AMENDMENT OF SOLICITATION/MODIFICATION OF CONTRACT			1. CONTRACT ID CODE	PAGE OF PAGES
2. AMENDMENT/MODIFICATION NO. 0001	3. EFFECTIVE DATE 14-Jun-2023	4. REQUISITION/PURCHASE REQ. NO.		5. PROJECT NO.(If applicable)

14. DESCRIPTION OF AMENDMENT/MODIFICATION (Organized by UCF section headings, including solicitation/contract subject matter where feasible.) The above numbered Solicitation for West Shore Lake Pontchartrain, Louisiana, Hurricane and Storm Damage Risk Reduction Project, Levees and I-10 West T-Wall Crossing, WSLP-106, St John the Baptist Parish, Louisiana has been amended to: a) Provide updated plans and specifications. b) Provide updated bid schedule. c) Provide answers to prior questions d) All questions are due NLT 11:00am CST on June 22, 2023 e) Bid submission date changed to June 29, 2023, at 10:30am CST				
Except as provided herein, all terms and conditions of the document referenced in Item 9A or 10A, as heretofore changed, remains unchanged and in full force and effect.				
15A. NAME AND TITLE OF SIGNER (Type or print)		16A. NAME AND TITLE OF CONTRACTING OFFICER (Type or print)		
		TEL:	EMAIL:

WSLP-106 PRE-BID QUESTIONS

SHEET IDENTIFICATION
C-200

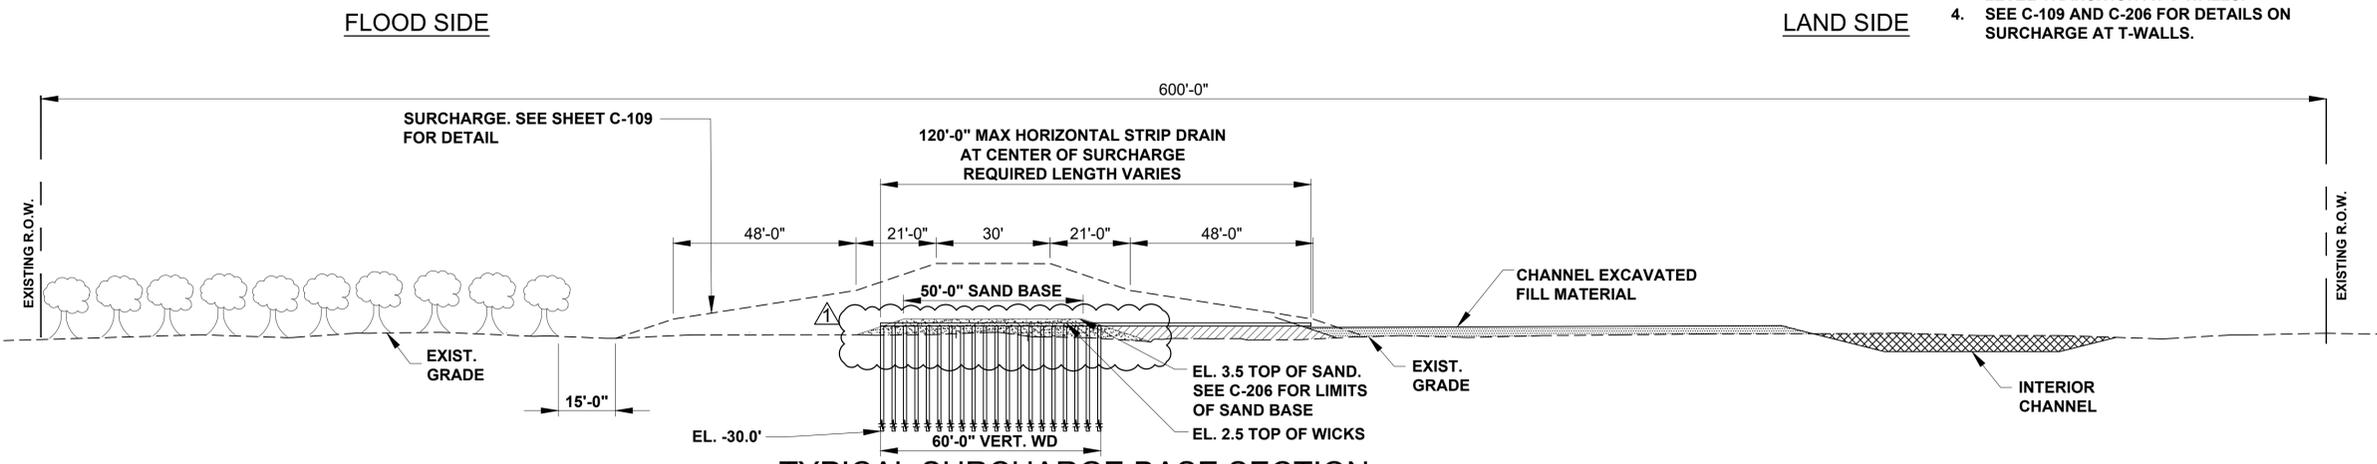
DATE	DESCRIPTION	APPR.	MARK
6/6/2023 <td>REVISE SAND BELOW EXISTING GRADE <td></td> <td></td> </td>	REVISE SAND BELOW EXISTING GRADE <td></td> <td></td>

SHEET
IDENTIFICATION
C-201

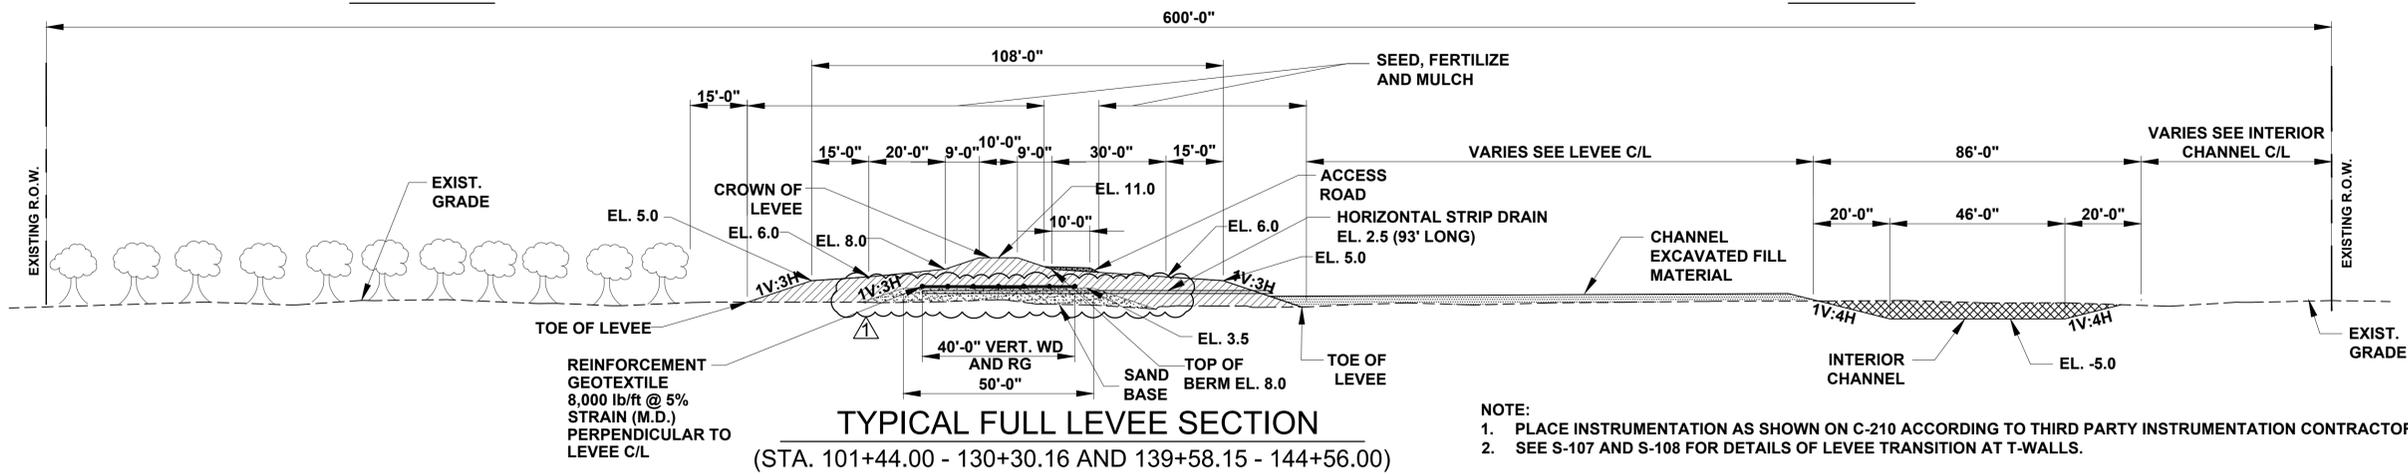
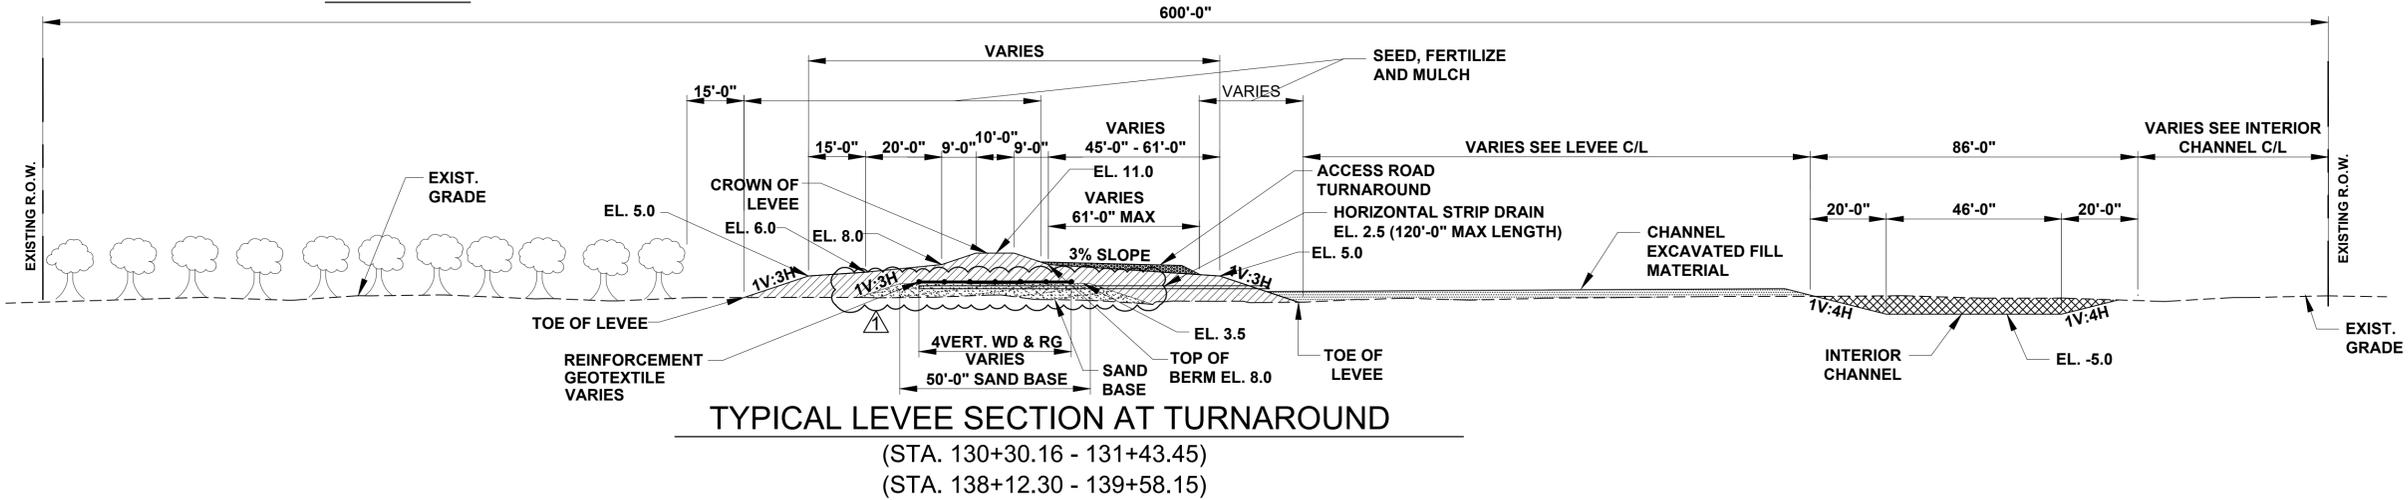
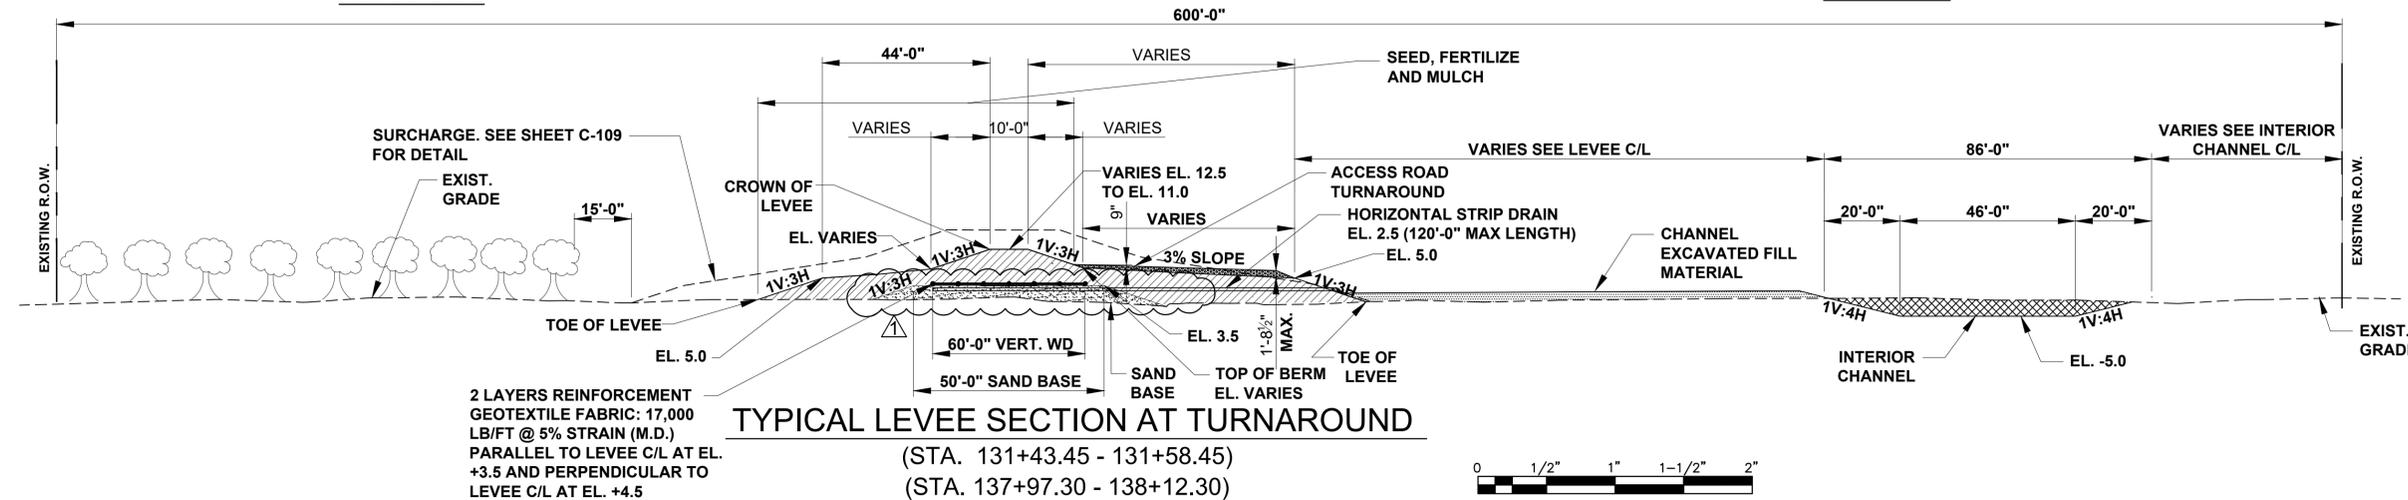
46. "Please confirm the total width of the reinforcement fabric in regards to both "Typical Levee Section at Turnaround" on Sheet C-201, "Typical Levee Section at Grouted Riprap" on Sheet C-202, and "Typical Sections" Monoliths T1 and T11 and Monoliths T2 and T10 on Sheet C-202." **Refer to C-206 for the Geotextile within the surcharge. The rest of the levee is a constant width.**

DATE	DESCRIPTION	APPR.
6/6/2023 <td>REVISE SAND BELOW EXISTING GRADE <td>MARK</td> </td>	REVISE SAND BELOW EXISTING GRADE <td>MARK</td>	MARK

SHEET IDENTIFICATION
C-202

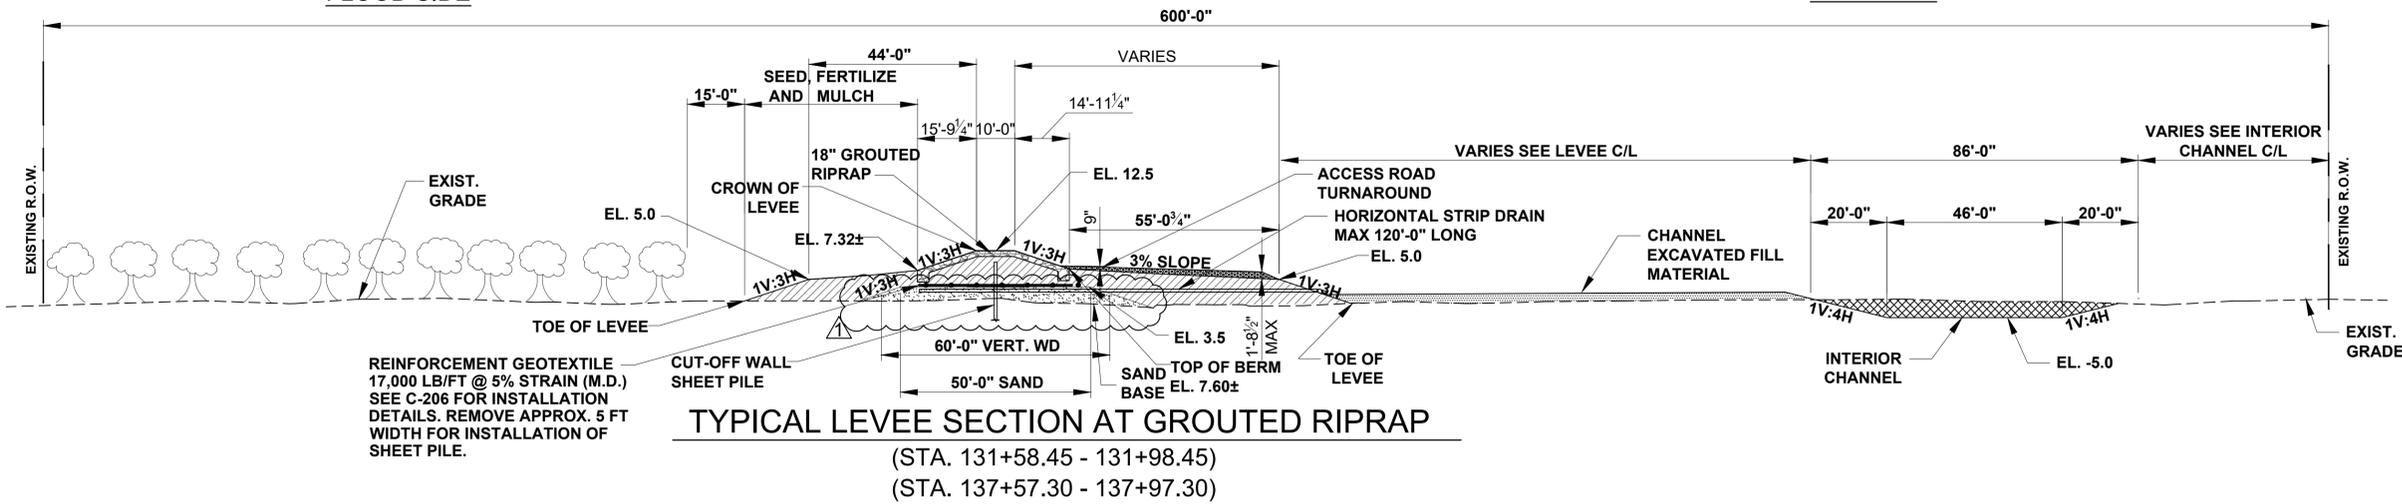
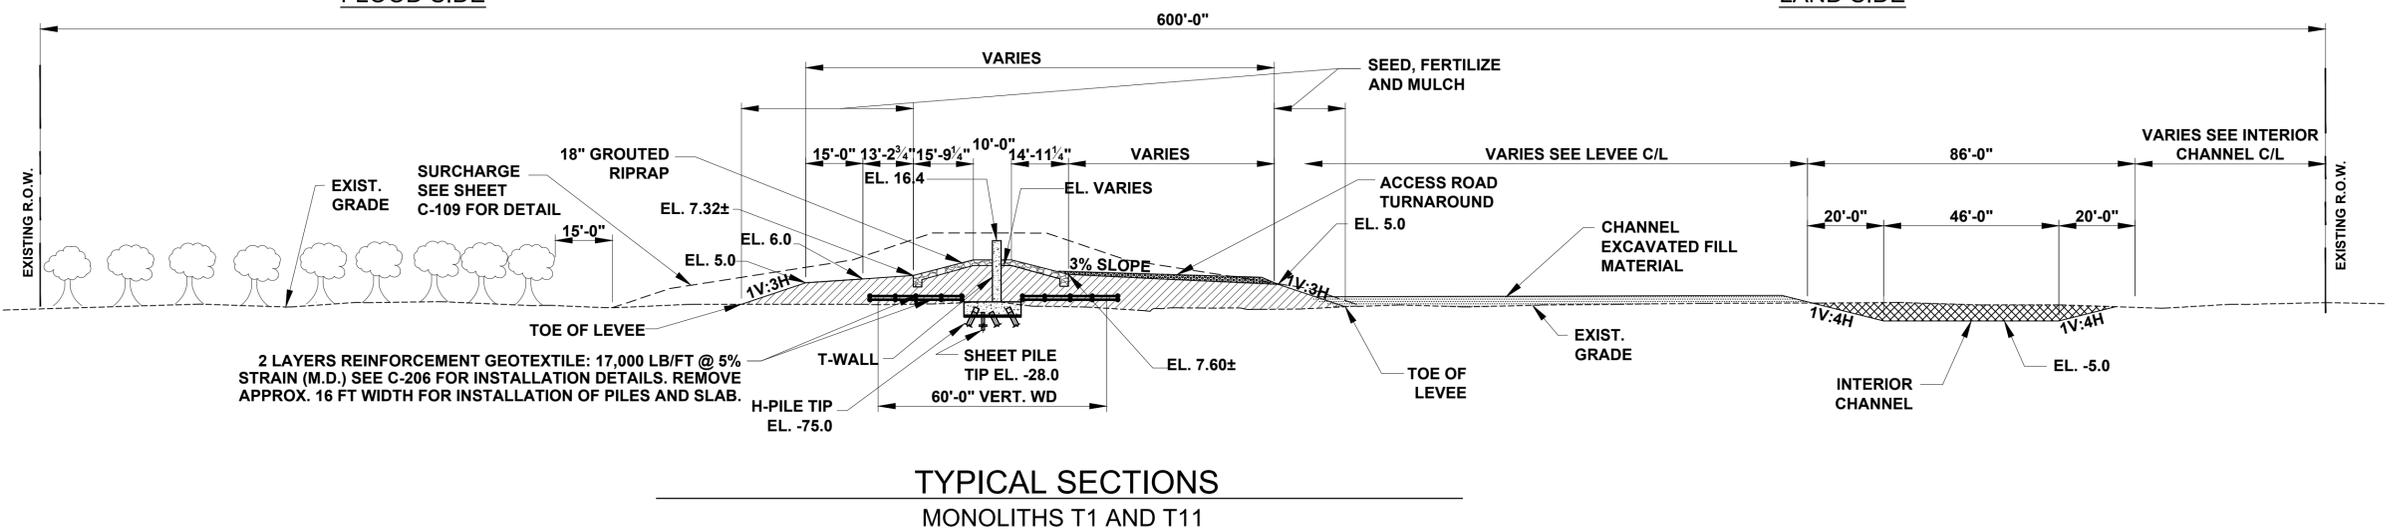
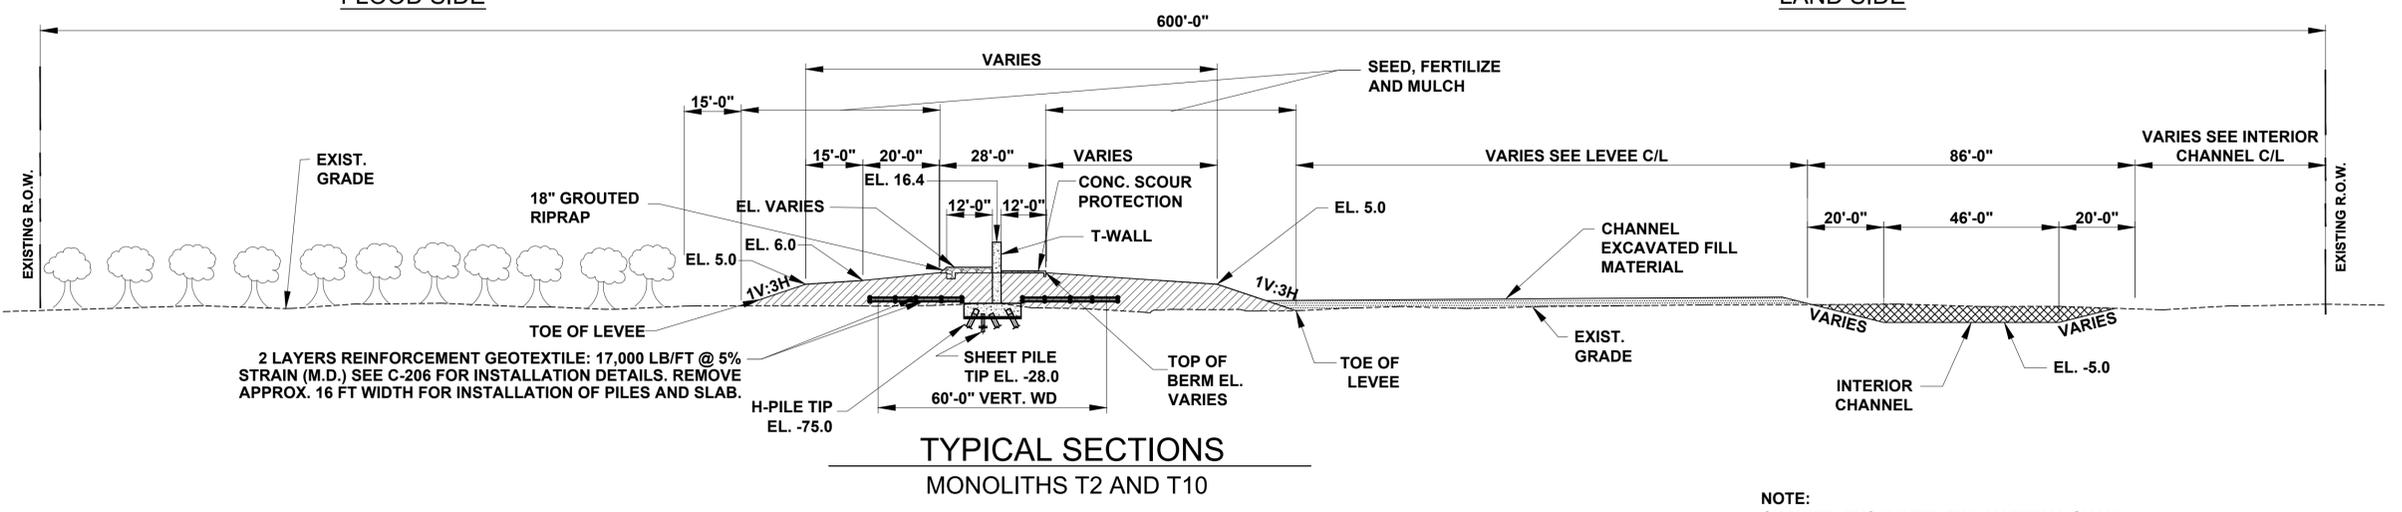
DATE	DESCRIPTION	MARK
6/6/2023	REVISE SAND BELOW EXISTING GRADE	Δ
